**HIROSE ELECTRIC CO., LTD.**

## **Notice of Change in Production Site of the DF11 Series (SMT Type) and Change in Shape and Production Site of Reinforcement Fittings, and Request for Your Acknowledgement**

#### ■ Change in shape of reinforcement fittings (indicated within red circle)

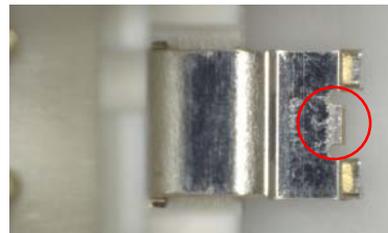
Previous fittings

After change

Furthermore, the shape of the reinforcement fitting was changed to improve productivity.

There is a slight difference in the shape of the reinforcement fitting, but the products' performance remains unchanged.
